**PUBLIC ADVOCATES OFFICE**  
**CALIFORNIA PUBLIC UTILITIES COMMISSION**

**REPORT ON PLANT PROJECTS FOR  
WHITTIER-LA MIRADA SYSTEM**

**SUBURBAN WATER SYSTEMS  
TEST YEAR 2024 GENERAL RATE CASE**

San Francisco, California  
August 14, 2023

## Figure 2-1: Inflation Calculation with US CPI Data

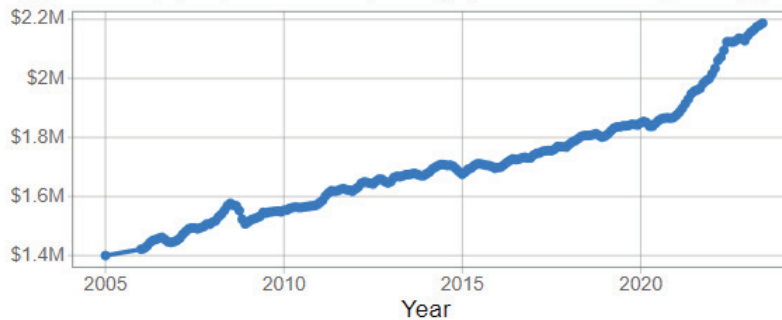
3 The production well drilling cost of \$4 million without equipment (and \$5.3  
4 million with equipment) is too high compared to other Suburban well projects and other  
5 Class A water utility’s well projects in the vicinity of Suburban’s territory. When  
6 Suburban constructed Well 3 in 2005 at Plant 409, the total cost of construction - drilling  
7 and equipping and new well - was \$1.4 million.<sup>57</sup> According to DDW, Plant 409 Well 3  
8 production capacity is 2,500 gpm<sup>58</sup> which is more than double that of the proposed new  
9 well at Stage Road which is expected to be 1,000 gpm.<sup>59</sup> In this GRC, Suburban requests  
10 \$4.2 million for drilling the production well, and equipping the well for additional \$1.1  
11 million, totaling \$5.3 million. By using an online inflation calculator using the average  
12 consumer price index data, \$1.4 million in 2005 is the equivalent of \$2.2 million in 2023,

13 factoring in inflation.<sup>60</sup> Please see Figure 2-1 below for calculation. Suburban’s request  
14 for \$5.3 million to drill and equip a new well is unreasonable.

Figure 2-2: EPA Construction Cost Estimate for PFAS Treatment<sup>82</sup>

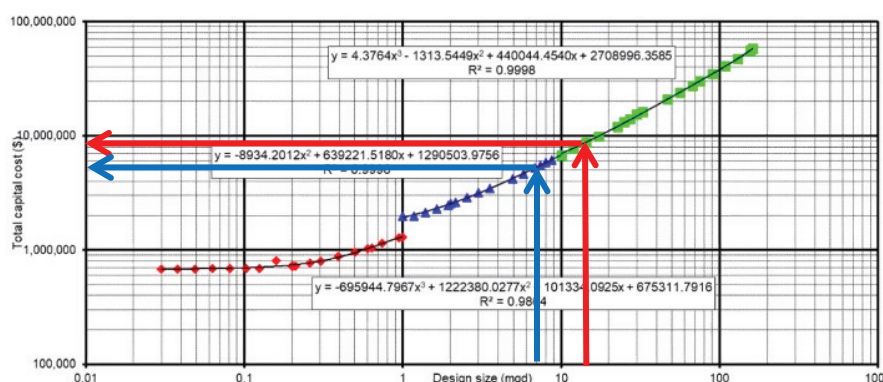
1  
2 Suburban's estimated maximum capacity is 10,000 gallons per minute (gpm).<sup>83</sup>  
3 10,000 gpm translates into 14.4 mgd. On the EPA's chart, the reasonable capital cost of a  
4 treatment should be about \$9 million (red arrow). This is assuming the treatment will run  
5 at its full capacity of 10,000 gpm for 24 hours which is highly unlikely. Treated water  
6 from the proposed treatment facility at Plant 201 will be exclusively delivered to  
7 Suburban's Plant 224 which has two concrete reservoirs with 7.1 million gallons (MG)  
8 combined capacity.<sup>84</sup> Thus, it is reasonable to assume that the realistic run time of the  
9 proposed treatment should be less than 24 hours because 14.4 million gallons per day  
10 water from the wells would be too much for the 7.1 million gallon reservoirs. Suburban

8 Water systems in Southern California have been built or are planning for PFAS  
9 treatment with far less costs. For example, Yorba Linda Water District, a member utility  
10 of the Orange County Water District, is building a centralized PFAS treatment system  
11 that consists of 11 two-vessel (22 vessels in total) Ion Exchange system with 25 million  
12 gallons per day capacity for its 10 wells and the estimated construction cost is \$27.6  
13 million.<sup>86</sup> Comparing this estimate to Suburban’s 14.4 million gallons per day and 16  
14 total vessels<sup>87</sup> for \$42 million, Suburban’s cost estimate is too high.

**Figure 2-4: Disadvantaged Communities in Zone 285 and 335<sup>100</sup>**

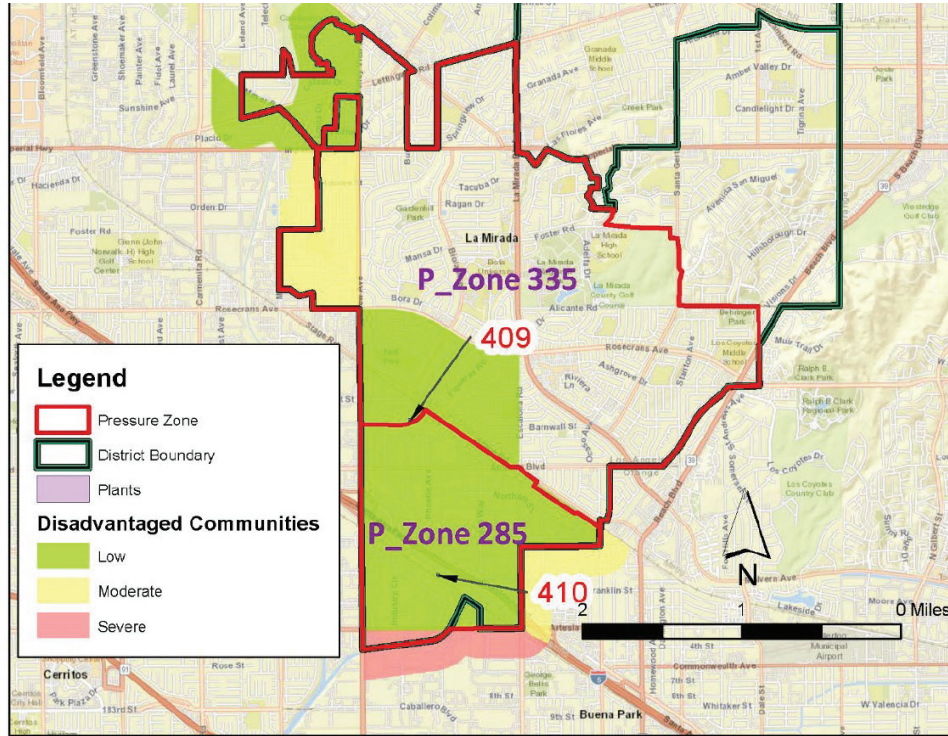
11 Additionally, Suburban introduces a map of disadvantaged communities in its La  
12 Mirada system and states “a portion of the customers served by Plant 410 W-1 in the  
13 Zone 285 and Zone 335 are in disadvantaged communities...”<sup>99</sup> See Figure 2-4 below  
14 which is from Suburban’s project justification: Volume III-D Planned Projects.

1 This is misleading because DDW’s Sanitary Survey Report states that Plant 410-  
 2 W-1 is not a major source to Zone 335 but that it mainly supplies Zone 285 and only the  
 3 extra water from pressure Zone 285 flows into a reservoir at Plant 409.<sup>101</sup> DDW’s report  
 4 also states that Zone 285 is located in a mostly industrial area of the City of La Mirada.  
 5 Suburban also states there are 601 commercial connections in the 285 zone and did not  
 6 mention whether it has any residential connections in Zone 285.<sup>102</sup> Suburban’s response  
 7 to Cal Advocates’ data request confirms DDW’s assessment on Plant 410 and Zone  
 8 285.<sup>103</sup> A Google Maps search shows there is no residential housing in Zone 285.<sup>104</sup>

**Figure 2-5: Zone 285 Google Maps Search**

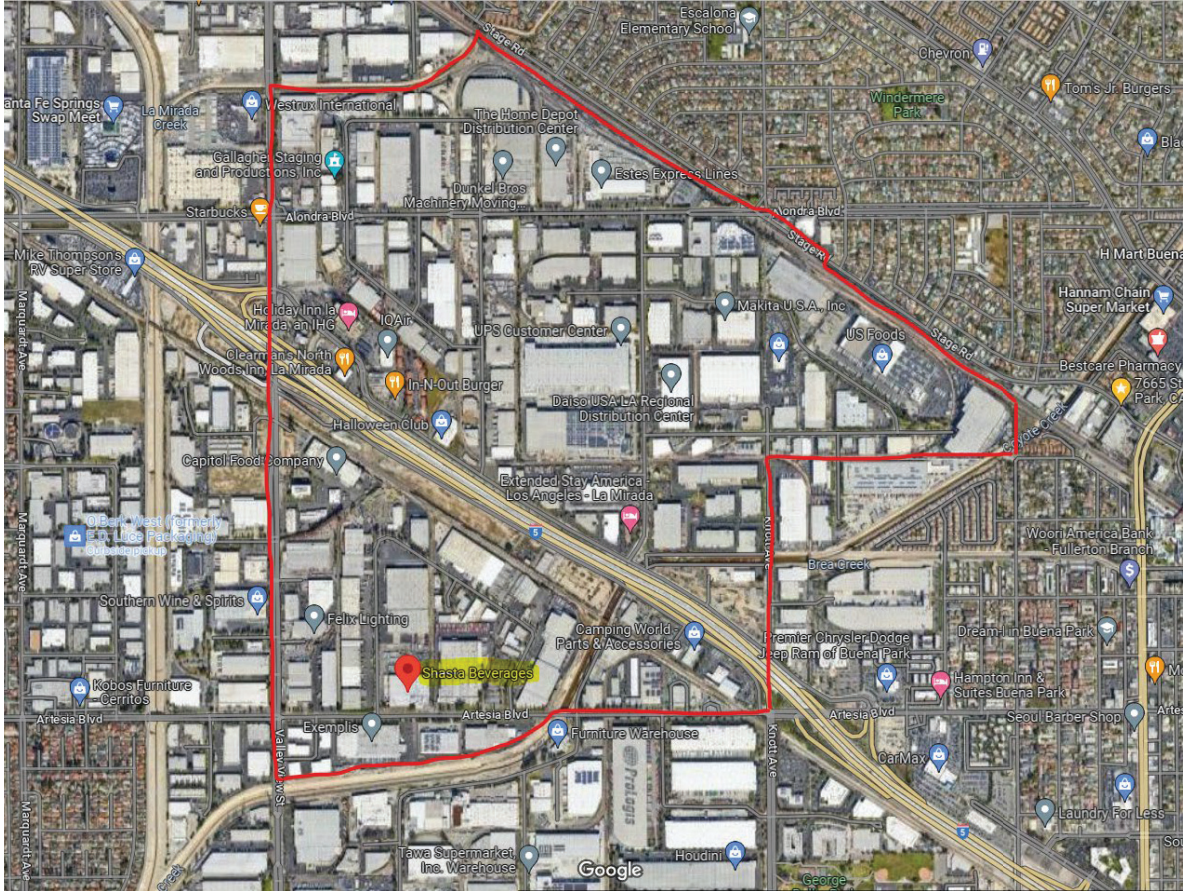
1 Using the context of a disadvantaged communities in the justification for a project  
2 that does not actually serve any disadvantage residences is inappropriate and detracts  
3 from the urgency and necessity to address real problems in disadvantaged communities.  
4 During Cal Advocates’ system tour of the La Mirada system, Suburban explained that  
5 Shasta Beverages is its biggest customer in the Zone 285 area. Shasta Beverages is  
6 located near Plant 410, within Zone 285. If improving the water quality for Plant 410 W-  
7 1 heavily benefits the water quality delivered to Shasta Beverages, there is a chance that  
8 Suburban’s La Mirada residential ratepayers would pay for a project that only benefits  
9 one of Suburban’s industrial customers.
